Chapter 4: Comments and Responses for the Draft EIS

4.1 Introduction

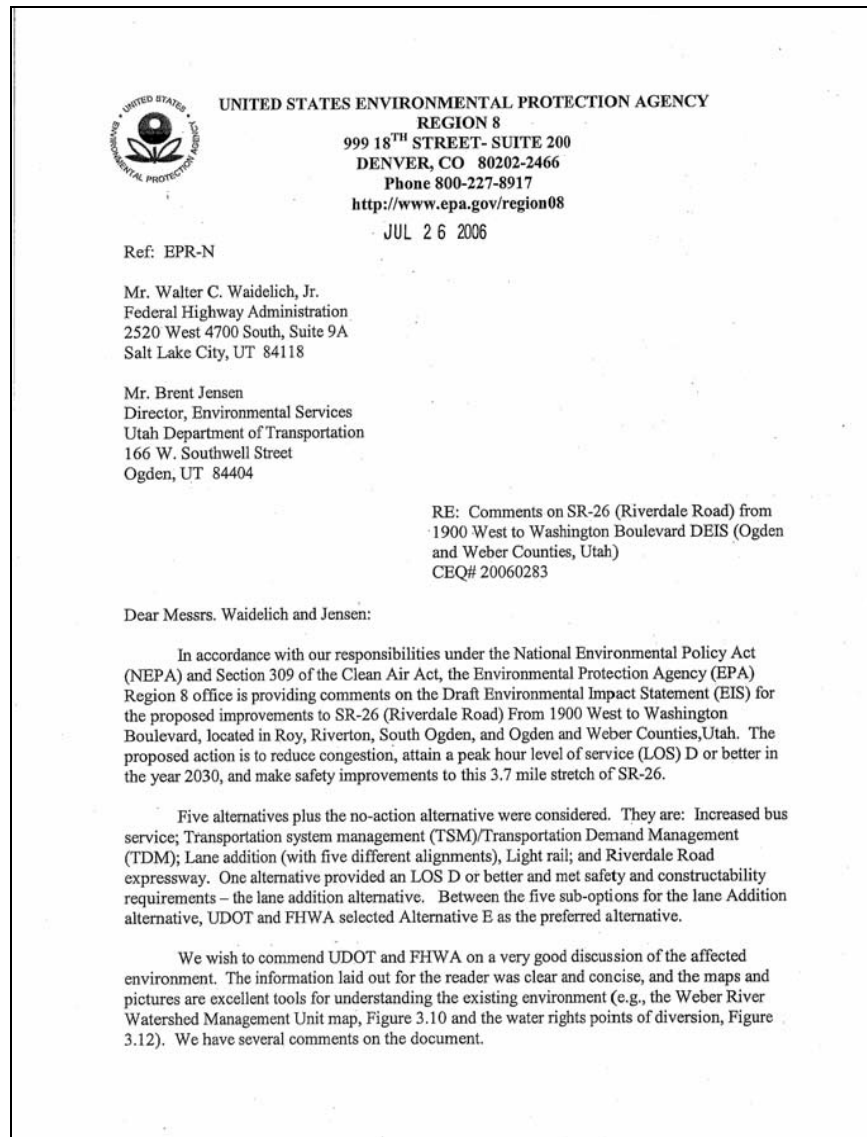
First of all, I question the wisdom of having the Riverdale Road project go all the way to Washington Boulevard. It appears that one possible stopping spot would be Chimes View Drive. That would be a good spot to stop the project. However, I think that an even better place to stop would be at 36th Street. At this point you could have one left-turn only lane, one right-turn only lane, and one lane going on to Washington Blvd. Your own traffic studies have indicated that as far as 25 years from now we can anticipate no serious congestion problems with no changes to this piece of Riverdale Road. There is, for sure, no need for two lanes coming off of Washington Blvd. as there is only one turn lane. There is no additional traffic added to this road until 36th Street. There are, however, two left turn lanes going from Riverdale Road onto Washington Blvd. At this time these lanes are not well-used because of poor signage. People all line up in the right-hand left turn lane so far back that only people with good local knowledge know that there are two left-turn lanes ahead.

Another bad idea that has been considered is making Kiesel one-way from 36th Street to Riverdale Road. That would impact my business seriously. A majority of my business comes from the South end of Ogden, and uses Washington Blvd. to get to me. There is no left-turn from Washington Blvd onto Riverdale Road. Nor should there be. It would require a 140 Degree turn to do it. The only reasonable way for those customers to get to me is to turn left onto 36th Street and then right onto Kiesel. I think it is critical that Kiesel not be modified in any way.

The proposed Riverdale Road project includes plans to widen the road from 36th Street to Washington Boulevard by adding one new lane in each direction. However, UDOT does not currently have available funds to construct the entire project. As noted in your comment, the segment from Chimes View Drive to Washington Boulevard operates at an appropriate level of service (LOS D) under 2030 No-Action conditions. Therefore, improvements to this segment are not likely to be made in the near future. If funds become available, UDOT will consider improvements including the steep gutter. There are no plans to make Kiesel Street a one-way street.

UDOT representatives did discuss your concerns at the public hearing for the Draft EIS and will consider your comments in making a decision on how to move forward with the project.
